Package 17

Teeple Architects Inc.

Reviewed
 Reviewed as noted
 Revise and resubmit
 Not Reviewed
 Date: SEP 24/15
 Reviewed by: M. Brown

PROJECT NAME:	SQ ALEXANDRA PARK - BLOCK11
DRAWING TITLE:	PLAN DETAILS
ARCHITECT:	TEEPLA ARCHITECTS
CONTRACTOR:	TRIDEL
SCALE:	1:4
DRAWN BY:	S.C.
DATE:	MARCH 4, 2015

PROJECT NAME:	SQ ALEXANDRA PARK - BLOCK11		
DRAWING TITLE:	PLAN DETAILS		
ARCHITECT:	TEEPLE ARCHITECTS		DRAWING No.:
CONTRACTOR:	TRIDEL		P4
SCALE:	1:4	DRAWN BY:	S.C.
DATE:	MARCH 4, 2015

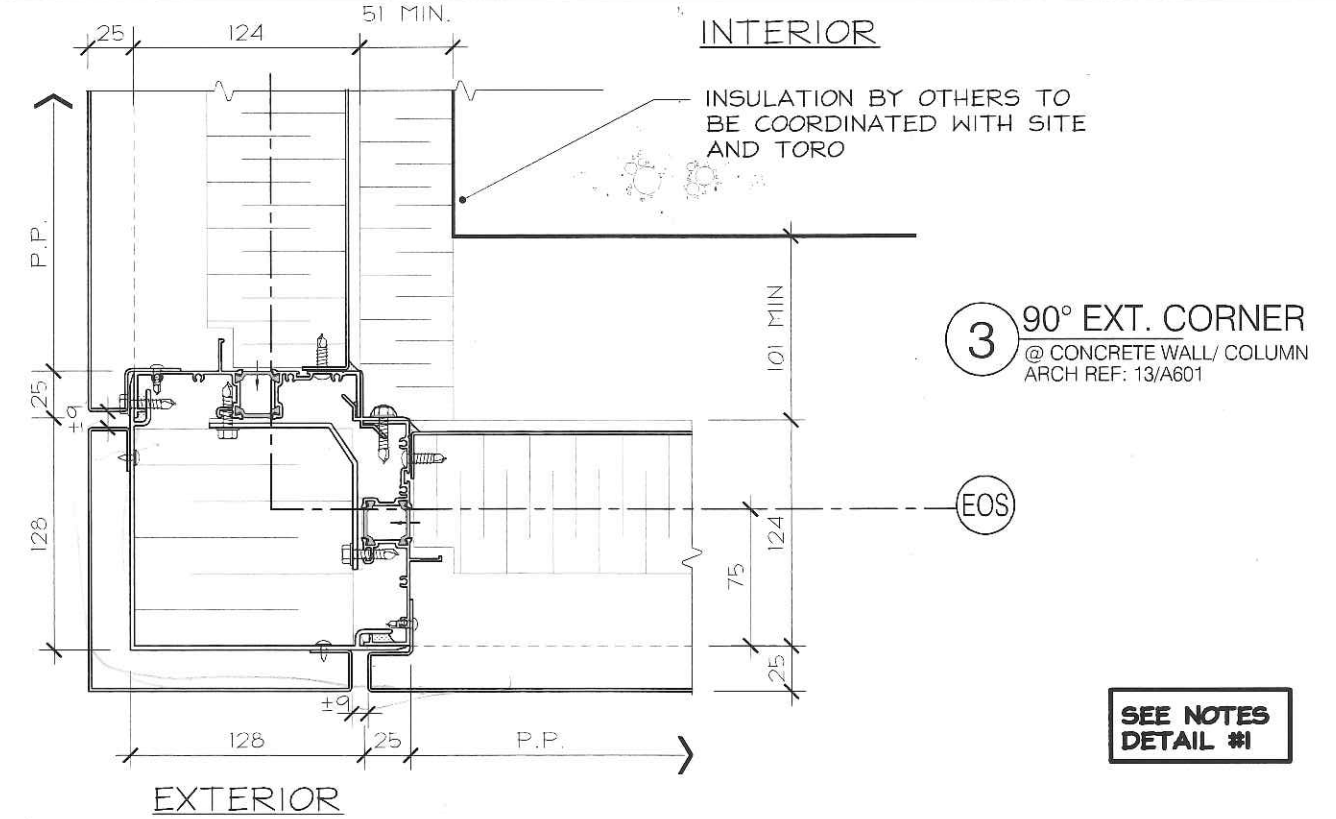
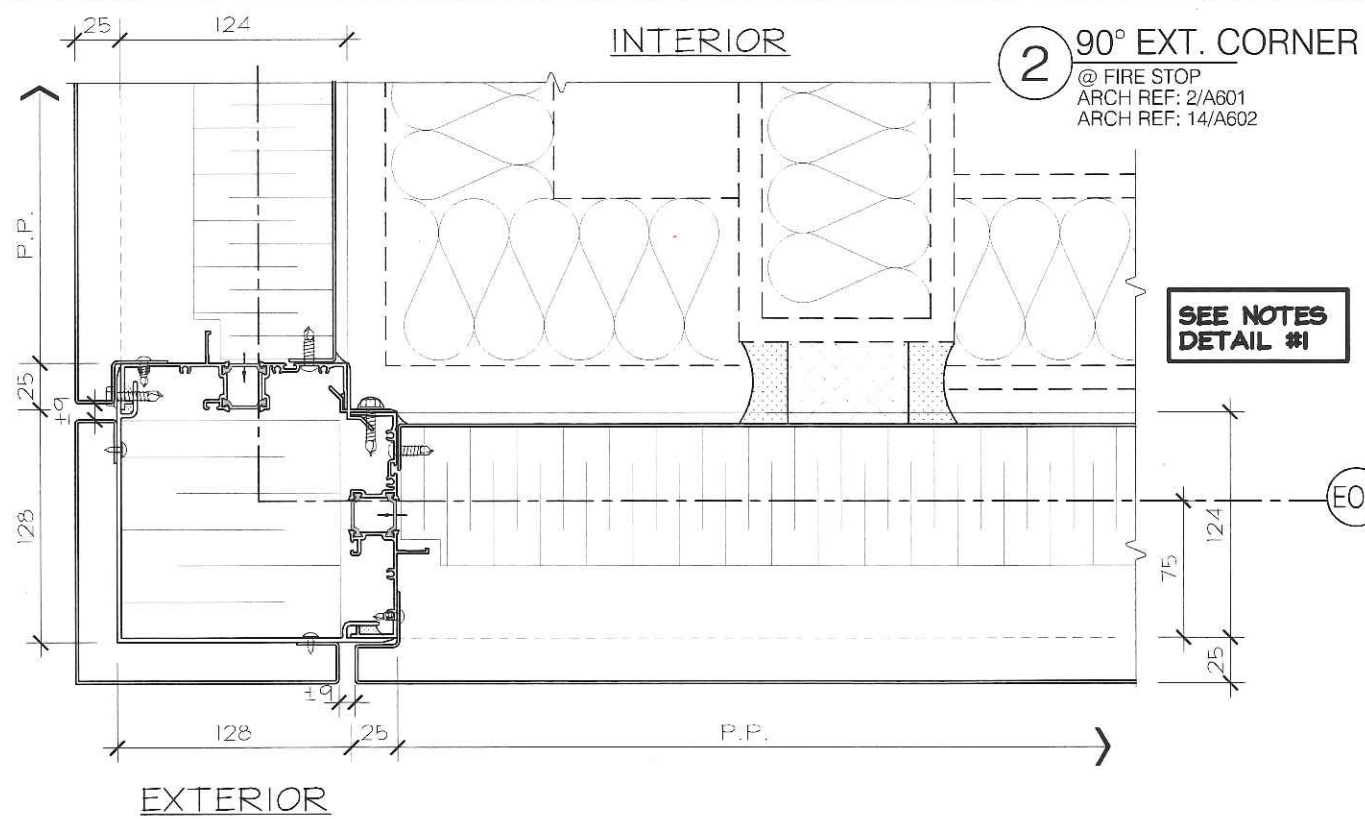
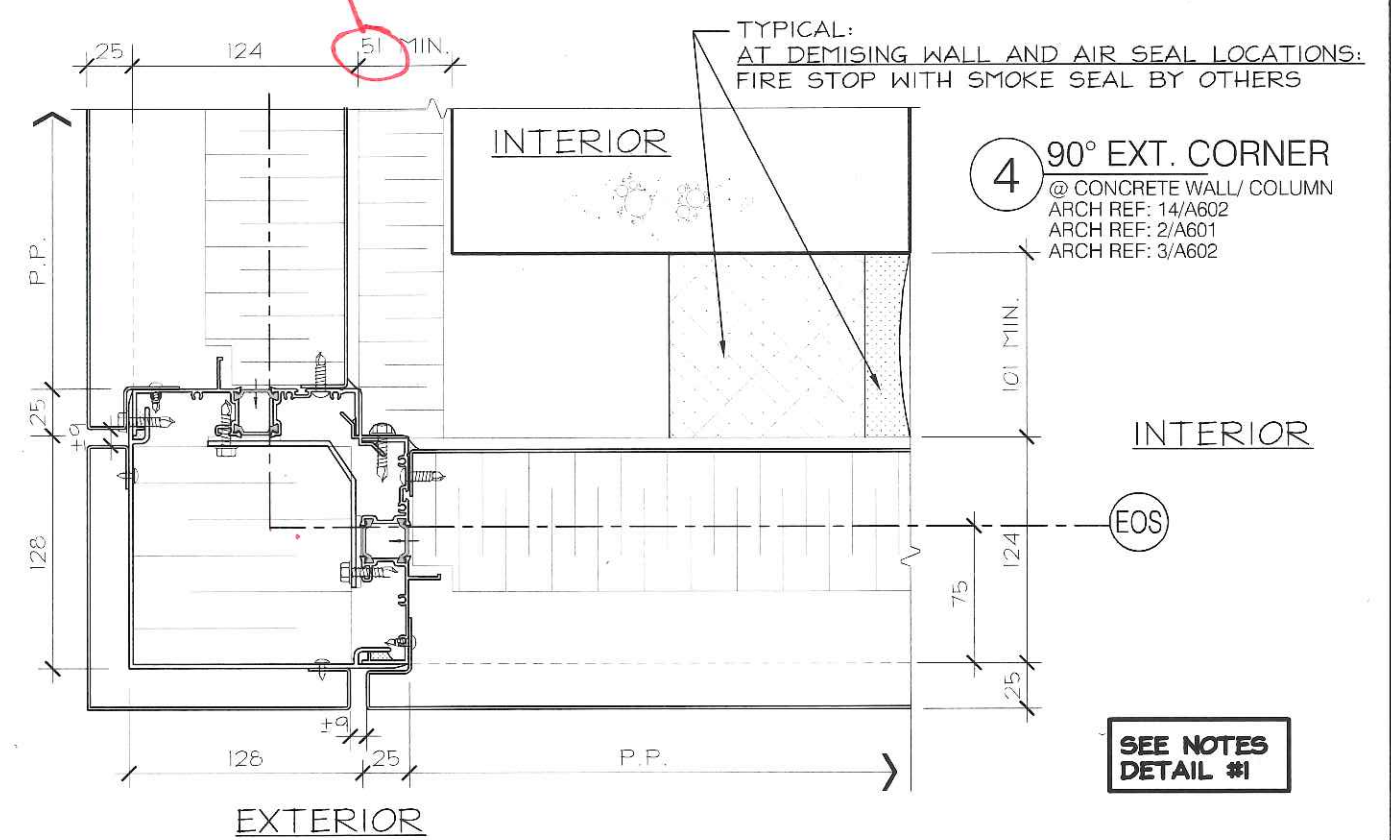
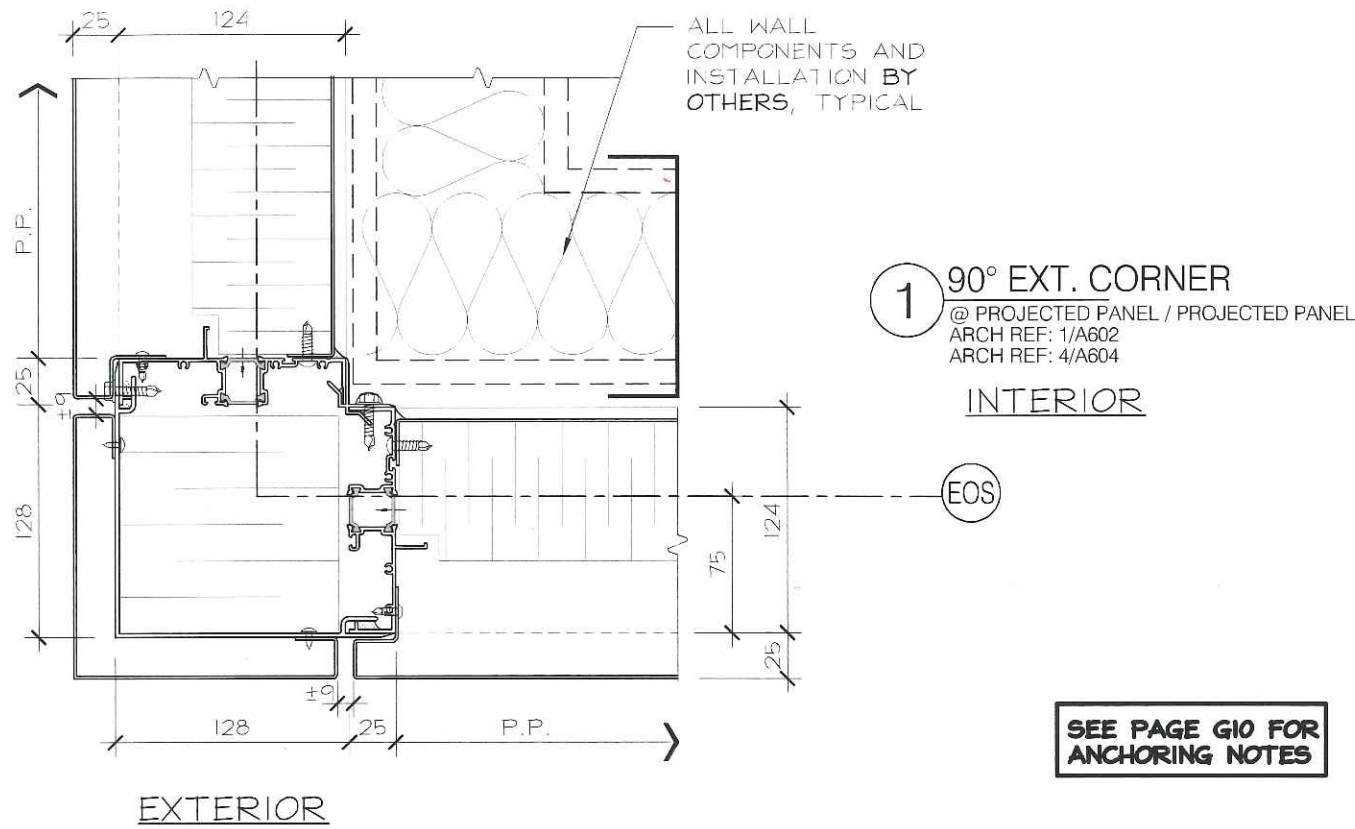
AT COLUMNS: 38 mm. REVIEWED W/ TORO IN DESIGN PHASE.

1 FIXED GLASS

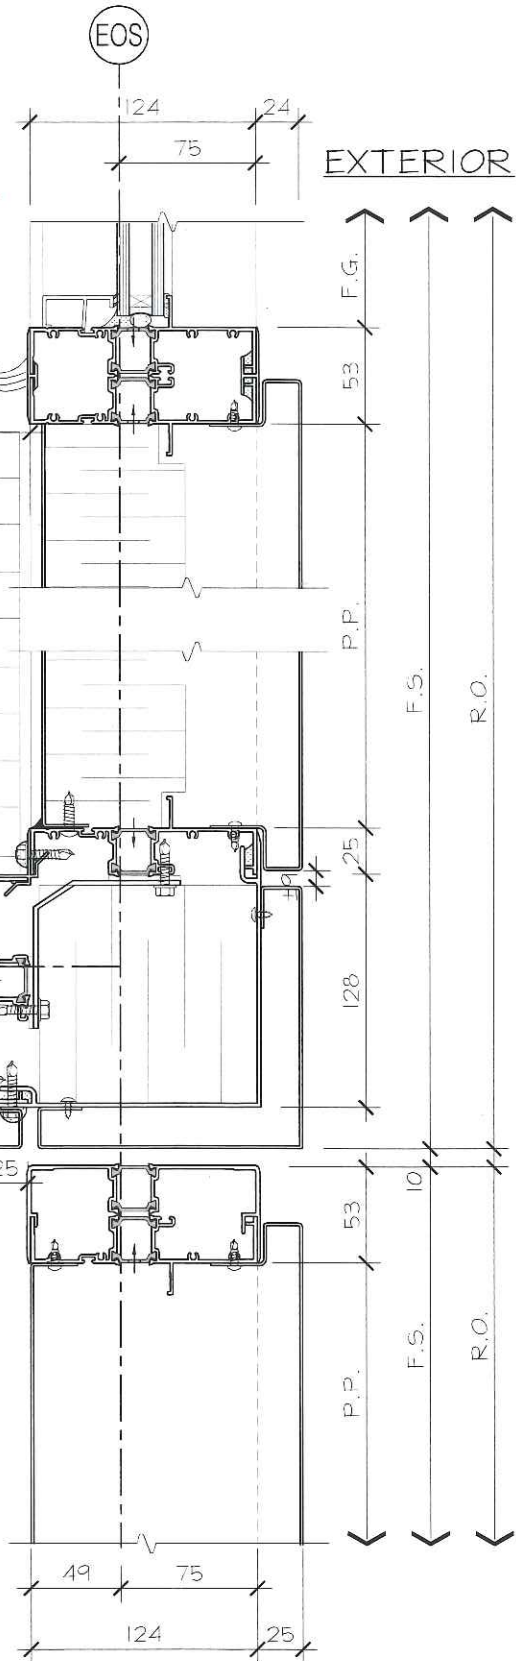
88mm IN YA605.

INSULATION BY OTHERS
 TO BE COORDINATED
 WITH SITE AND TORO

@ 73° CORNER
 ARCH REF: 1/A603

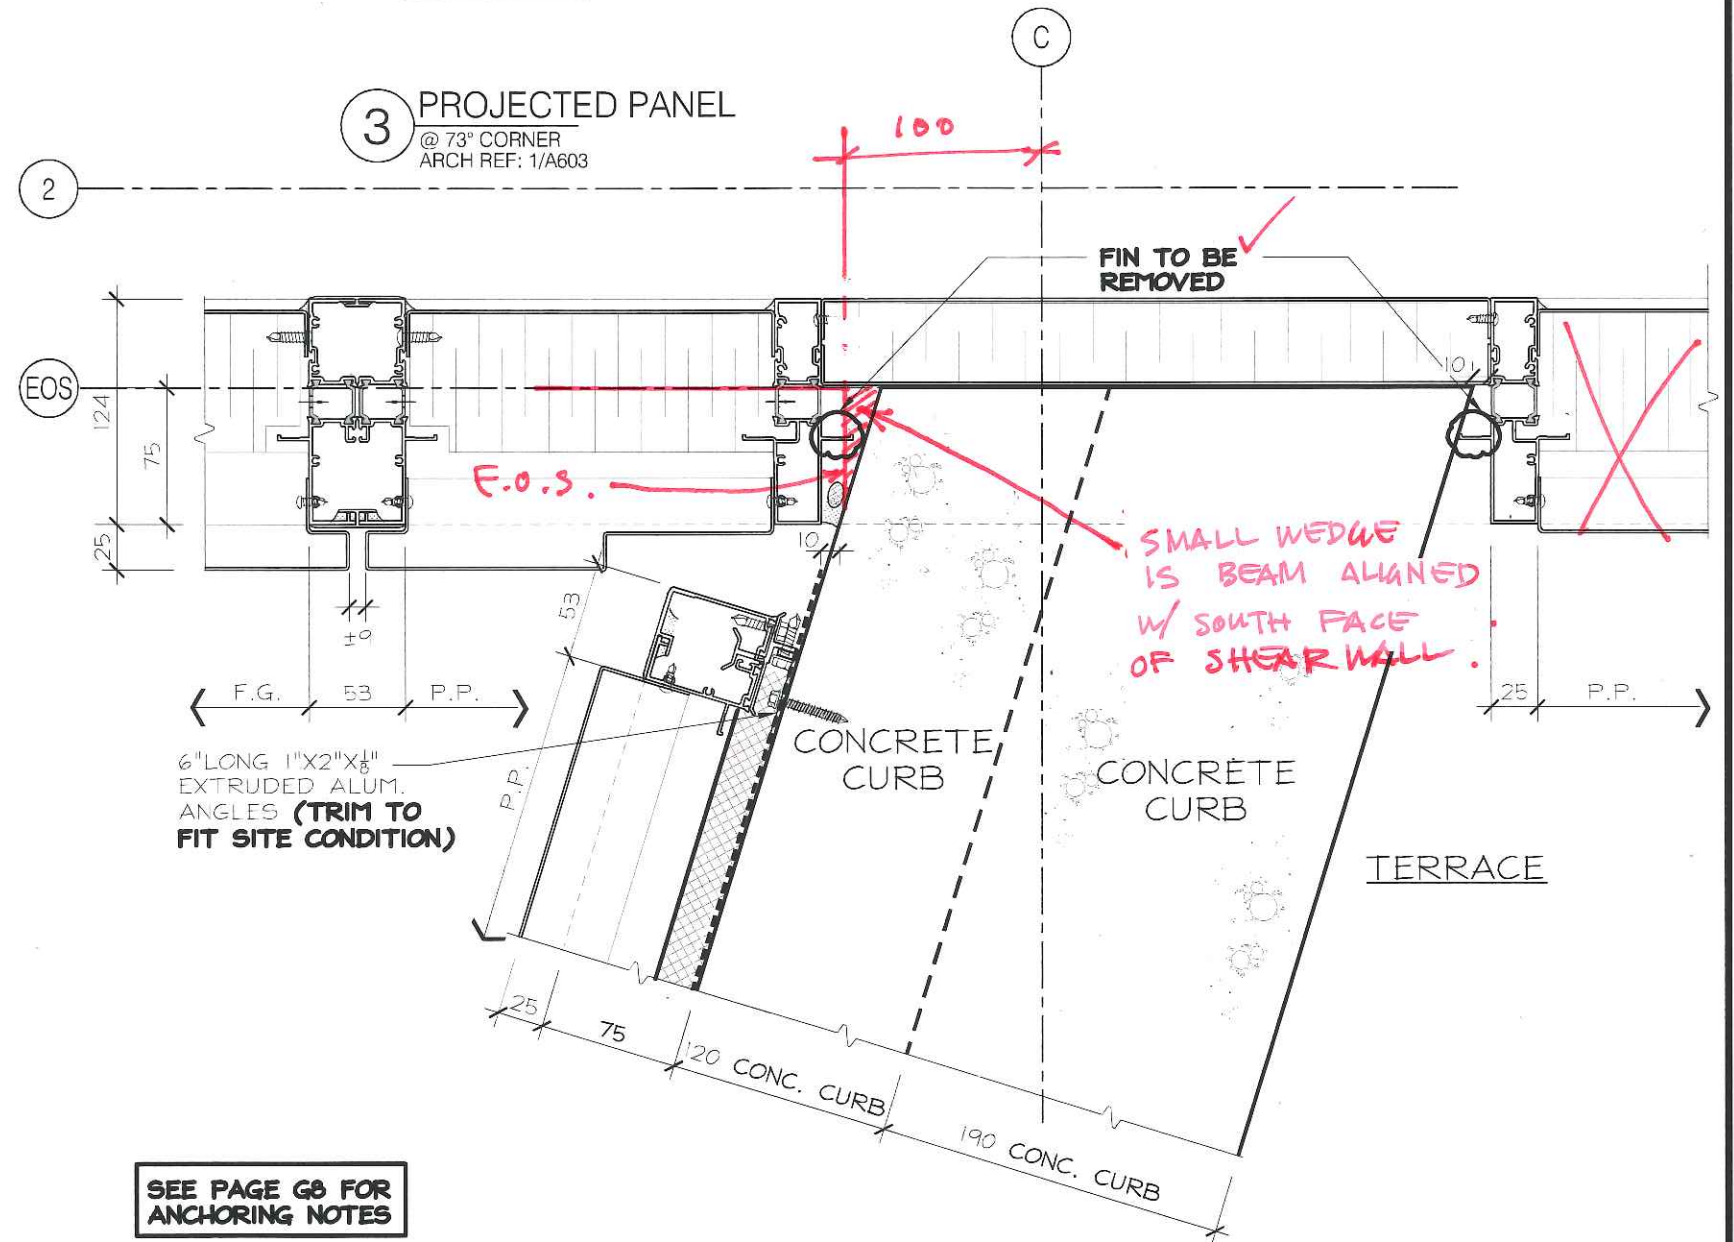
FIN TO BE
 REMOVED

*SMALL WEDGE
 IS BEAM ALIGNED
 W/ SOUTH FACE
 OF SHEAR WALL.*

PROJECT NAME:	SQ ALEXANDRA PARK - BLOCK11		
DRAWING TITLE:	PLAN DETAILS		
ARCHITECT:	TEEPLE ARCHITECTS		DRAWING No.:
CONTRACTOR:	TRIDEL		P8
SCALE:	1:4	DRAWN BY:	S.C.
DATE:	MARCH 4, 2015

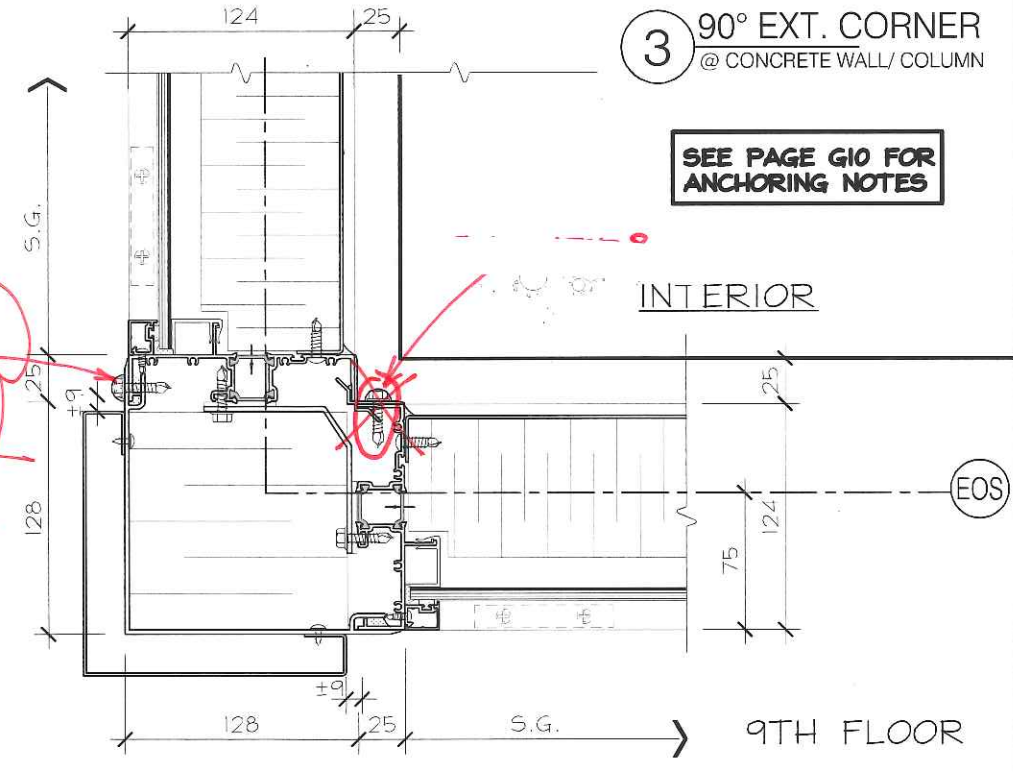
NO EXPOSED
 FASTENERS
 PERMITTED
 REVISE &
 RESUBMIT

4 FIXED GLASS
@ FIXED
ARCH REF: 4/A601

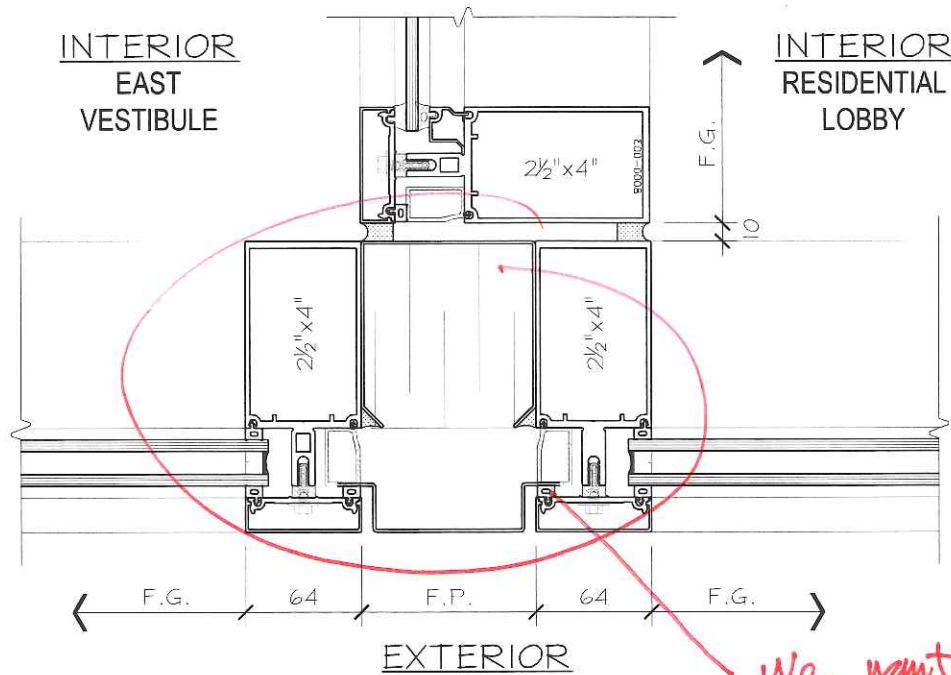
We want a single mullion here, not a double.
